July 3, 2008

Thanks for your help with this project. I've attached my instructions to our model builders. The instructions aren't finished but I thought that I'd show you what I have so far.

Les Randolph's CHP Buick

1955 BUICK CENTURY
1:25 #31295
SPECIAL EDITION

55cent_spot_correct.jpg

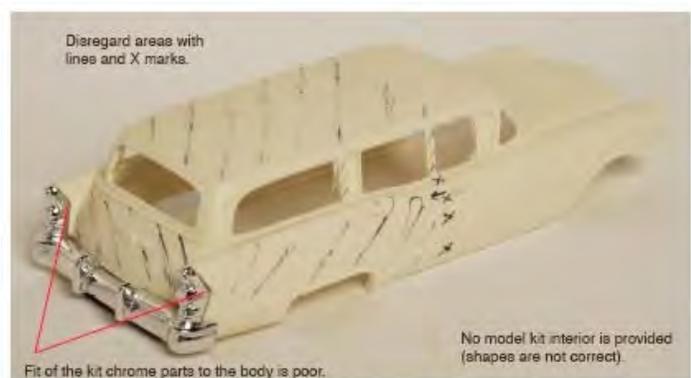
The two spot lights in other photos are the correct size and position, but are too new for 1955. Add the bulge on the top and add the thicker ring around the lens as shown above.

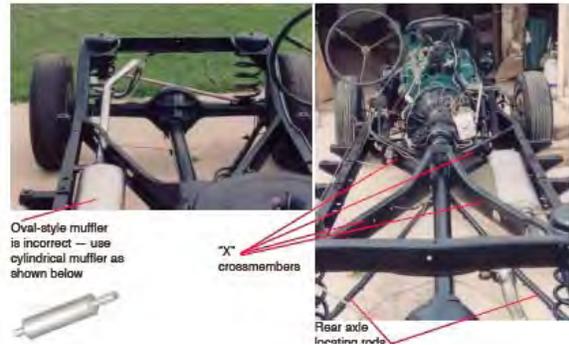
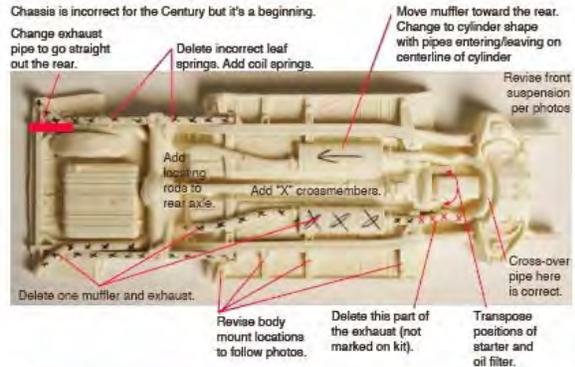
Disregard areas with lines and X marks.

No model kit interior is provided (shapes are not correct).

Fit of the kit chrome parts to the body is poor.

Trunk badge is not wide enough and is poorly shaped.

Kit rear bumper is good.

Model kit is of a 4-door station wagon.
 Needs to be changed to a 2-door sedan.
